**Response to Request for Information and Amended DA  
Advertising Sign – Ash Road, facing M7 Motorway, Prestons (DA23/16892)**

This letter has been prepared by *Keylan Consulting Pty Ltd* (Keylan) on behalf of the Applicant, Transport for NSW (TfNSW) to address the Department of Planning, Housing and Industry's (DPHI) Request for Information (RFI) dated 3 June 2024 in relation to Development Application DA23/16892.

### Response to issues raised by DPHI dated 3 June 2024

Figure 1: Sign Location – M7 Upgrade (Source: TTPP)

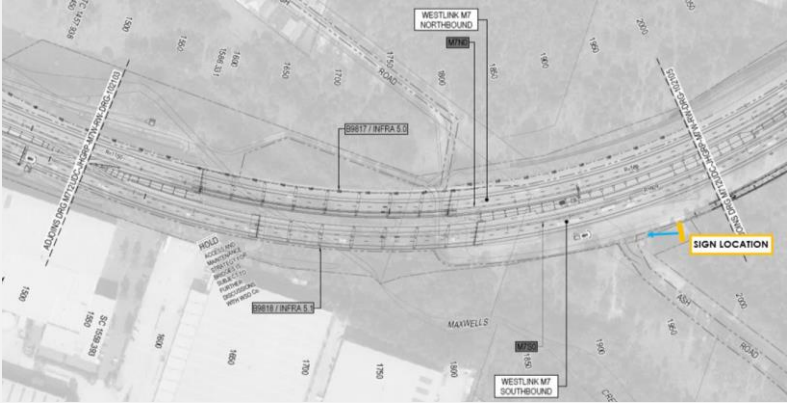
2.1	An assessment of road safety impacts of the sign on widening of the M7 Motorway, noting that the M7 Widening was approved on 17 February 2023 and is currently under construction in the median of the M7 in the general area of the proposal	A Signage Safety Assessment (SSA) has been prepared by The Transport Planning Partnership (Attachment B). The SSA includes an assessment of road safety impacts associated with the sign and M7 Widening project.  An extract from the relevant section of the SSA is provided below ( <b>bold</b> our emphasis). In summary, the widening of the M7 Motorway is not expected to result in any significant changes which would impact driver behaviour or the road environment.  <i>'To support future development growth in Western Sydney, and to provide a boost to the road network in Western Sydney, the NSW</i>

Ref.	Issues raised	Response
		<p>Government has commissioned the M7-M12 Integration project, which includes three major elements:</p> <ul style="list-style-type: none"> <li>• <i>M7-M12 Interchange: a connection between the new toll-free M12 Motorway and the existing Westlink M7 Motorway.</i></li> <li>• <i>Elizabeth Drive Connection: a new connection between the M12 Motorway and Elizabeth Drive, and the realignment of Wallgrove and Cecil Roads at Cecil Hills.</i></li> <li>• <i>Westlink M7 Widening: a new lane in each direction within the existing median of the M7 between the M5 and Richmond Road, excluding at the Westlink M7/M4 Motorway (Light Horse) Interchange.</i></li> </ul> <p>Of these elements, the only change to the road environment within vicinity of the sign will be the widening of the M7 Motorway which began construction in October 2023. The location of the sign has been overlayed on the road alignment and detail plan in Figure 2.6. Detailed road upgrade plans have been provided in Appendix B.</p>

Ref.	Issues raised	Response
		<p><i>Based on the plans, it is not known how much vegetation will be removed from the median if any, though this likely will only increase the visible distance towards the sign. However, as discussed, the sign is likely only to be recognised at a distance of 110m which will remain consistent with the existing environment and <b>therefore there is not expected to be any significant change to driver behaviour or the road environment. Due to the alignment of the road, the additional lane within the existing median will have a very similar readable distance and visible distance to Lane 1 and Lane 2.</b></i></p> <p><b><i>The road widening project does not introduce any decision making or conflict points in vicinity to the sign and the changes are largely limited to an additional lane and the minor rearrangement of signs and other road infrastructure.</i></b></p> <p><i>The existing Variable Message Sign (VMS) will be shifted slightly west to be clear of the additional lane. As discussed in Section 3.3.2.1 <b>the VMS does not have a backdrop issue with the sign, and this will continue to be the case in the new location.</b></i></p> <p><i>It is proposed to adjust some sign locations as shown in the plans in Appendix B, however the signs are not expected to move more than a few metres. <b>Their effectiveness is not expected to be impacted by the sign due to its location on the far side of the road.</b></i></p> <p>In light of the above, the SSA concludes that the proposed sign is acceptable from a road safety perspective.</p>
